STAFF REPORT

SUBJECT:	PRS 21-0357 GCN	PLANNING AREA:	Greater Carrollwood Northdale
REQUEST:	Minor Modification to a Planned Development	SECTOR	NW
APPLICANT:	Benjamin M. Berry, P.E. – Berry Engineers LLC		
Existing Zoning : PD 74-0004		Comp Plan Category: RES-4

APPLICATION: PRS 21-0357
ZHM HEARING DATE: N/A
BOCC MEETING DATE: July 20, 2021

Figure 2 – 1984 approved Site Plan

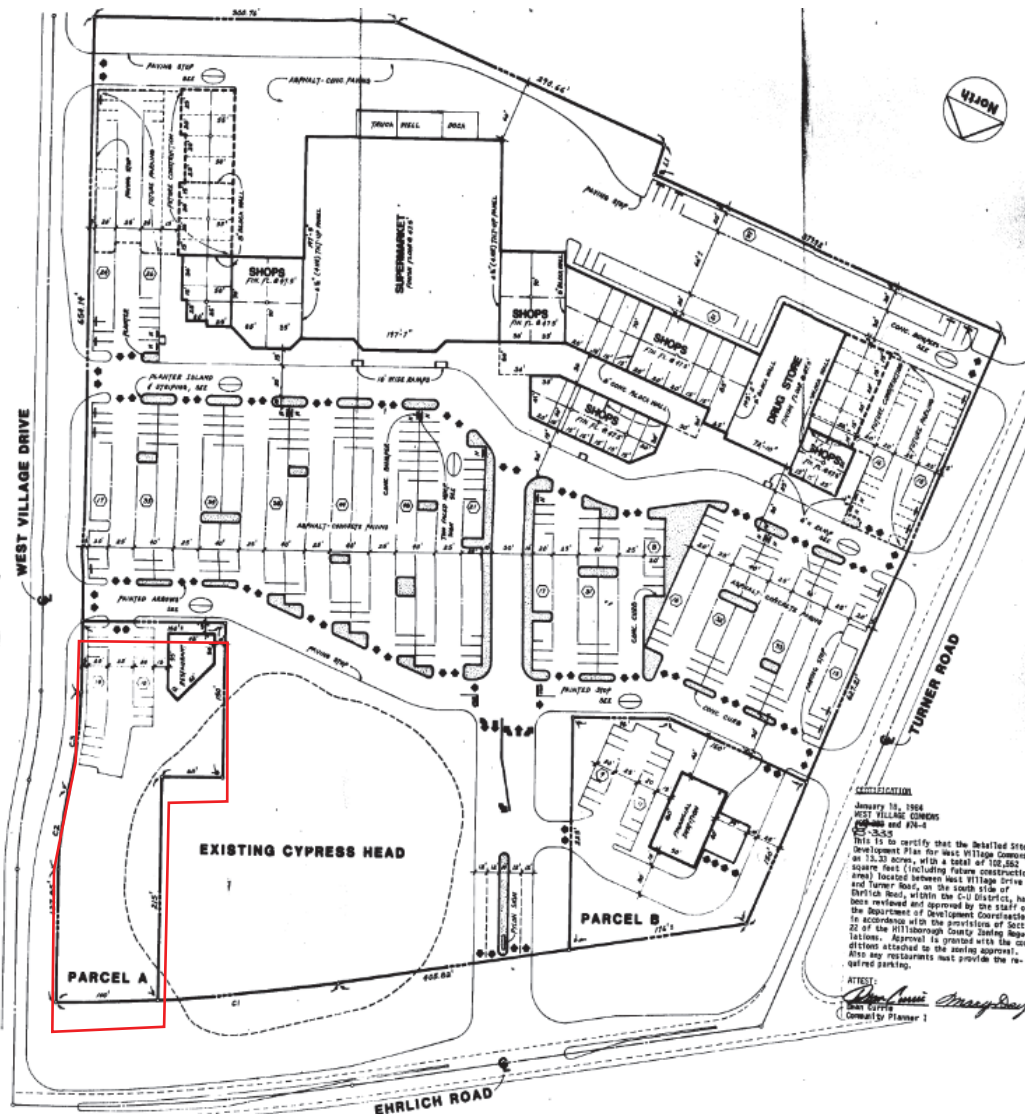
The site received approval in 1984 for a shopping center with two outparcels as a Community Unit, which were site-detailed plans required by old Code regulations. The plan showed a sit down restaurant, 2,400 sq. ft. in size in Parcel 'A' (the area affected by this Minor Modification). This old plan was approved but Parcel A was never developed. The rest of the shopping center site (Parcel 'B' and the larger commercial parcel) are built out.

Figure 3 – Proposed Automated Car Wash site

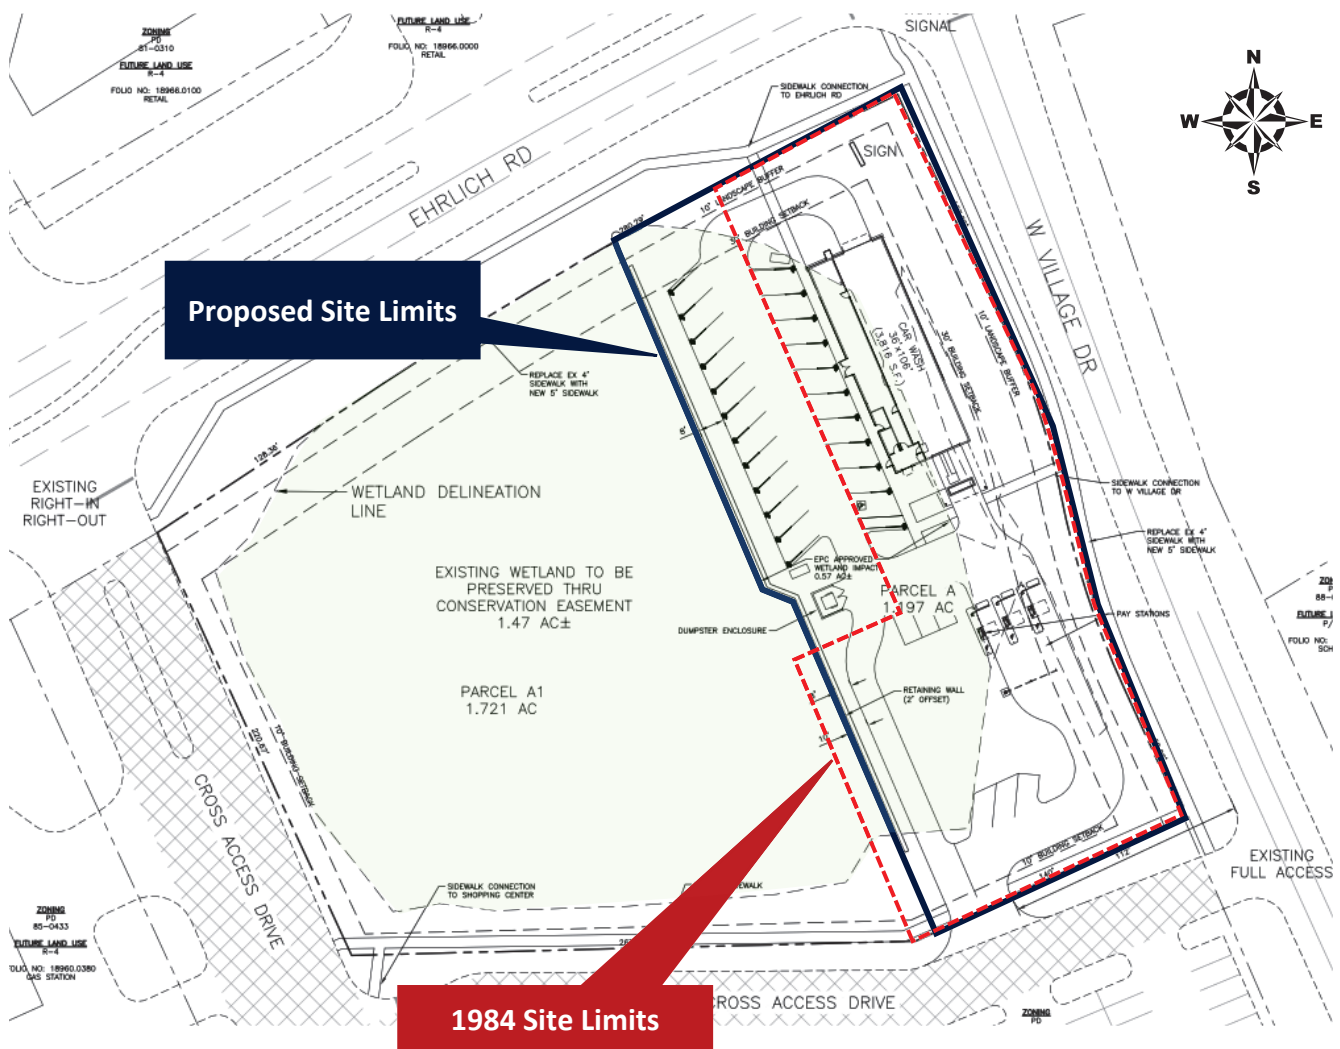
The PRS requested is to modify the boundaries of the existing 'Parcel A', as labeled and approved in the 1984 detailed site plan for the existing shopping center. The modification adjusts the configuration and boundary of the outparcel (Parcel A) to reflect the area authorized by the Hillsborough County Environmental Protection Commission, EPC, for impact, places the balance of the Property in a conservation easement, and accommodates current development standards. The proposed car wash use is an approved/permitted use on the Property, and entitlements are available for the square footage required, since the shopping center is within the .25 FAR permitted within the Res-4 Land Use category. The development was part of the Carrollwood DRI and PD approved in 1974 which has been substantially built out. The applicant has submitted a project table and map calculating existing built commercial and office development within the overall PD to the Planning Commission to ensure entitlements are still available for the increase of square footage proposed by this project and to demonstrate the total FAR is still below the thresholds permitted by the Future Land Use(s) in the PD.

Figure 3 shows the proposed area of development compared to the area of the 1984 site plan approved by the County. The 1984 Site Plan allocated 0.98 acres of land for 'Parcel A', while the proposed land area for this new project would be 1.19 acres. Therefore, the area to develop the Car Wash represents an increase of approximately 0.21 acres of land.

34. The land area of Parcel A shall be limited to 1.197 acres and its configuration shall be as shown in the General Site Plan. The area of the building shall be limited to 3,816 sq. ft.

SHEET NUMBER:
2 OF 2

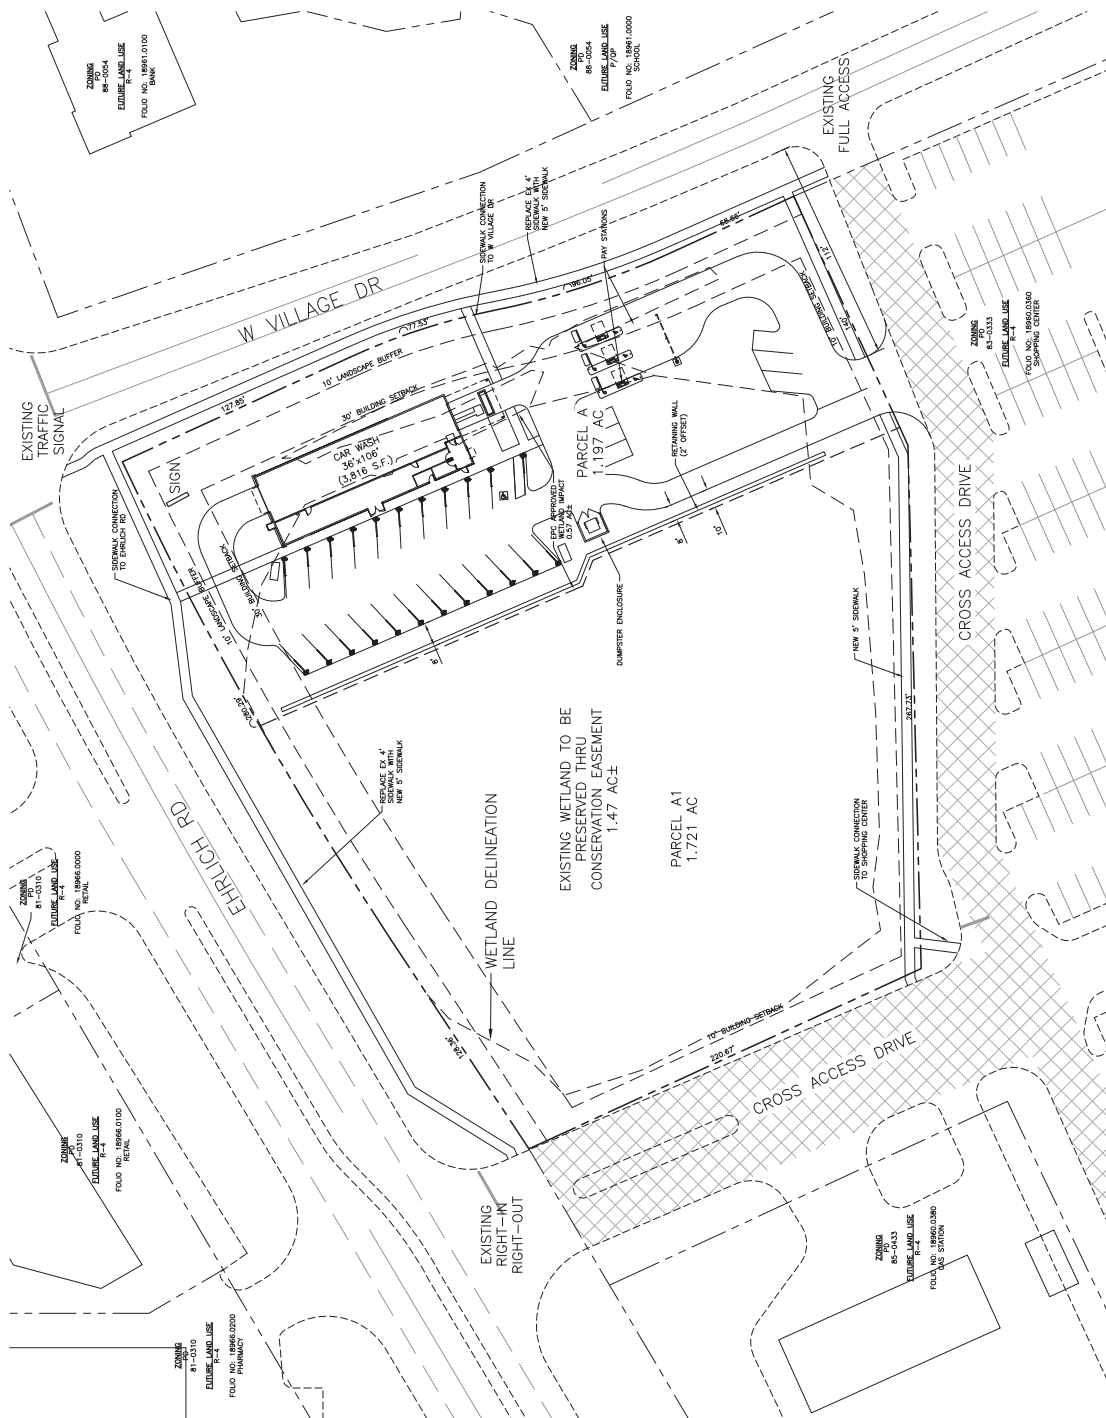
Sheet 2 of 2 of the GSP provides the details of the configuration and location of the proposed Car Wash facility. The site will have an access off the driveway entering the shopping center from West Village Dr.

New conditions (starting at #33) will be added regulating the development standards of the subject site, as well as provisions from the Environmental Protection Commission for the wetland impacts. Transportation conditions will also be added including road improvements. The development standards will be specified in Sheet 2 of 2 of the General Development Site Plan.

33. The property shall be limited to an Automated Car Wash facility within Parcel A, and shall be generally located as depicted in the submitted General Site Plan.
